RC3: 'Comment on amt-2022-185', Anonymous Referee #3, 21 Jul 2022

Author statement: The authors thank the referee for reviewing this manuscript. An itemized **response** for the rebuttal can be found below for each response given in **blue**. The tracked-changes version can be found below for each response in **red** and the already existing text is in *italic*.

Figure 2: Photograph of the modified POPS.

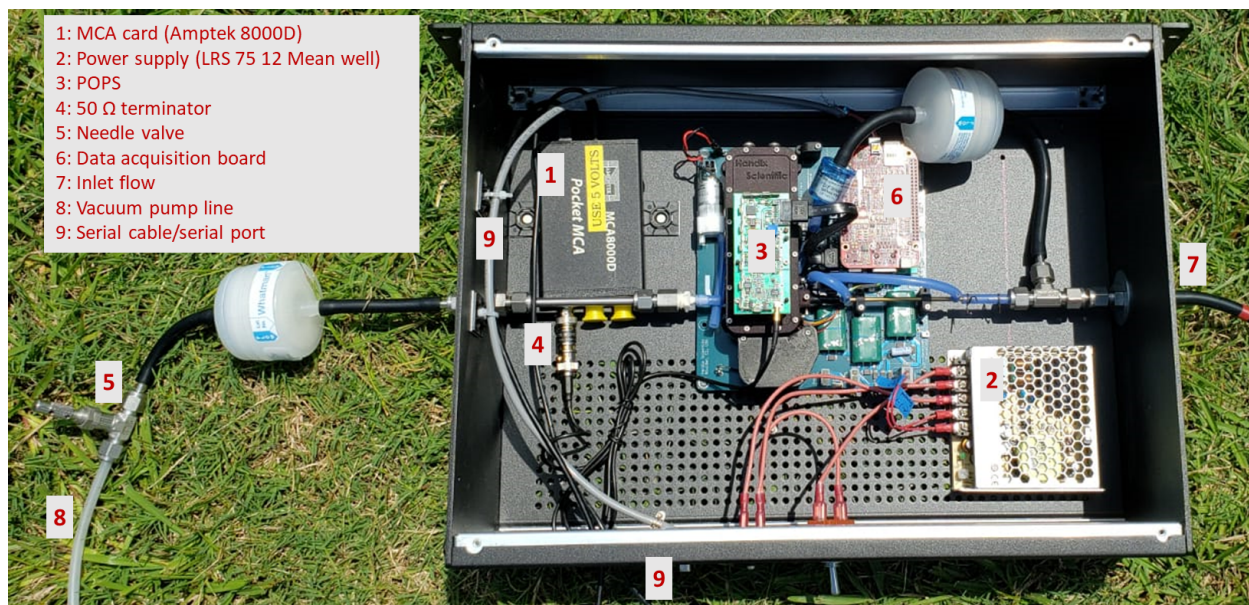
2. Reviewer would suggest showing a laboratory picture of modified POPS setup/instrument.

Response 2: **We added a picture of the modified version of the POPS.**
